**CONSTRUCTION DIRECTIVE (CD)**

**PROJECT:** Oak Street ES LAWA Sound Mitigation Project  
**CD Number: 02**

**TO:** Newman Midland Corporation – Adam Nasry  
**TITLE:** Phase 1- Demo Five (5) Hard Lid Ceilings –  
Bldg. B

REQUEST FOR INFORMATION (RFI)

Demo Locations -

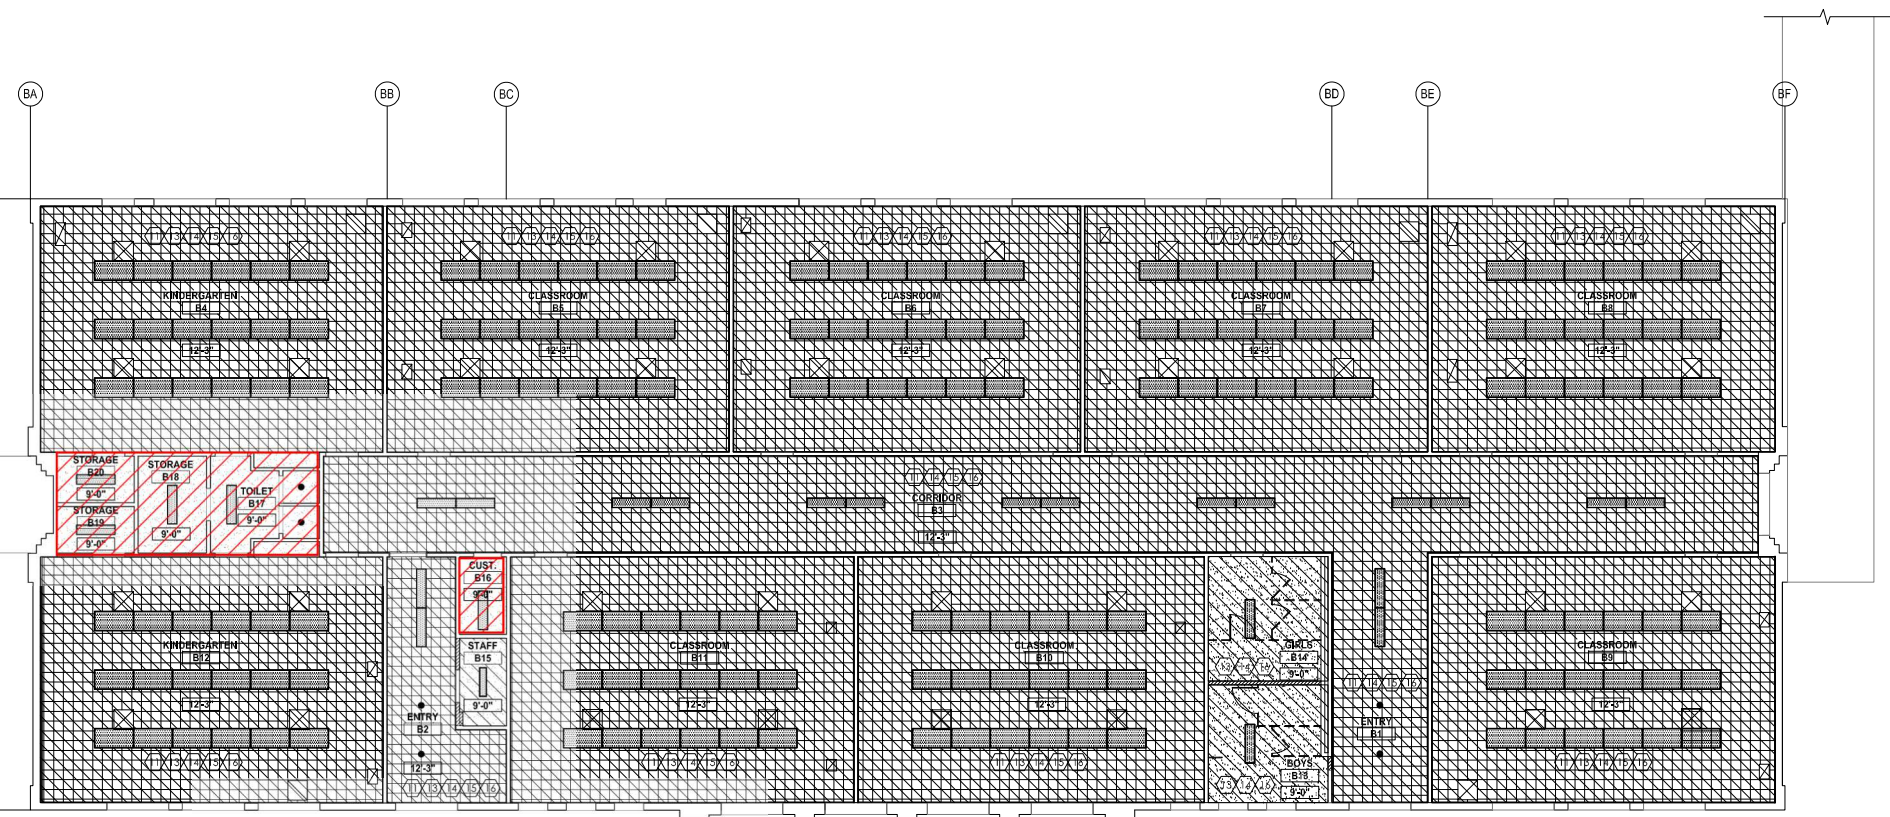
- I. Demo the existing hard lid ceilings at specified areas of Bldg. B. per RFI No. 016-R1 to obtain abatement clearance.  
-Please see attachment of areas of ceiling demolition and RFI No. 016-R1.

Per RFI#16 answer and Noel's subsequent email, we were requested to provide a proposal to Abate and Replace (E) asbestos ceilings in rooms B16 through 20. We propose to leave ceiling in the electrical room (B16) as is, due to extensive electrical work and panels in that room.

No exception. District to confirm request.

According to our on site inspector, and the abatement contractor's supervisor, the electrical room shares a common ceiling space with the hallway and room B11. The roofing debris cannot be left in order to achieve clearance for the work area. The ceiling and roofing debris must be abated.
